## DISTRICT OF WEST VANCOUVER

# COUNCIL REPORT

Date:	May 2, 2024
From:	Hanna Demyk, Planning Technician
Subject:	Proposed Development Permit with Variances at 2368 Bellevue Avenue
File:	1010-20-23-079

THAT the applicant for the proposed “Development Permit No. 23-079” for 2368 Bellevue Avenue be directed to revise their application to respond to staff advice as outlined in the report dated May 2, 2024.

Figure 4 – Section showing proposed retaining wall to the south of the site adjacent to the Centennial Seawalk.

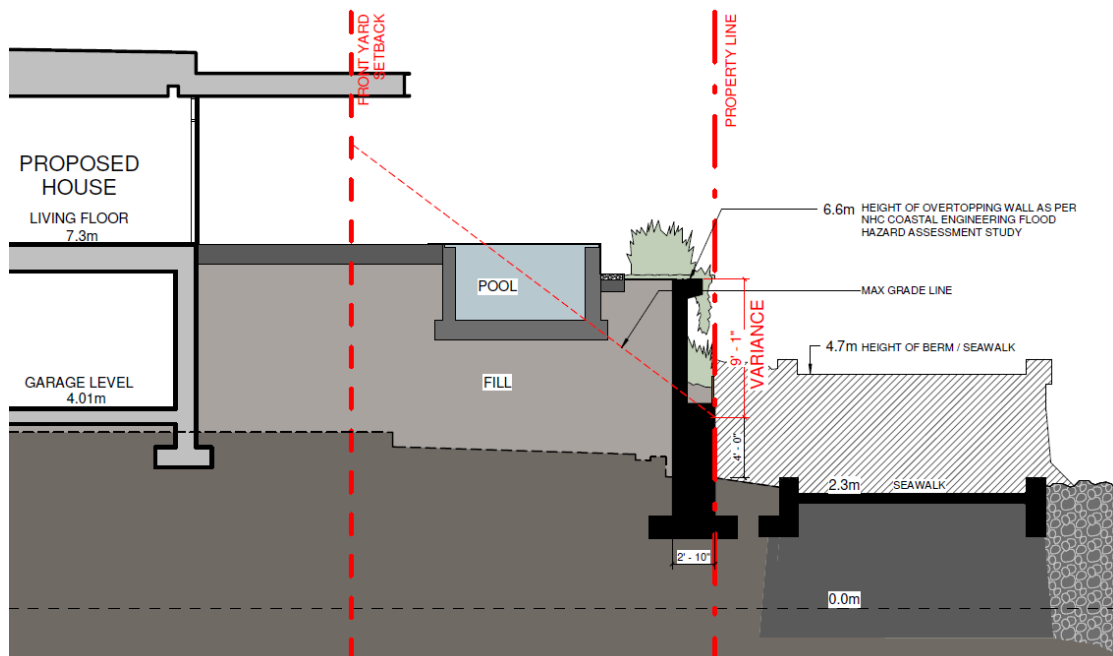
The applicant proposes zoning bylaw variances to retaining wall height and grade line angle as per proposed plans and outlined below (Figure 5). In general, the maximum permitted height of a retaining wall adjacent to a property line is 1.2 m. The retaining wall along the south property line is

proposed to be 4.1 m in height, 2.9 m taller than permitted in the zoning bylaw. The retaining wall along the west property line is proposed to be 2.3 m in height, 2.1 m taller than permitted in the zoning bylaw. The proposed retaining wall to the east of the site complies with zoning regulations adjacent to the property line but requires a variance to the required grade line angle. Overall, this would result in a significantly higher wall located adjacent to the Centennial Seawalk than would otherwise be permitted as shown in Figure 4.

- a. Revise the proposal to include additional stepped retaining walls in compliance with retaining wall and grade line requirements of the Zoning Bylaw, moving site protection away from the seawalk/public realm; or
- b. push the proposed raised retaining wall further behind the property line to provide additional landscaping and buffering between the private and public realm.
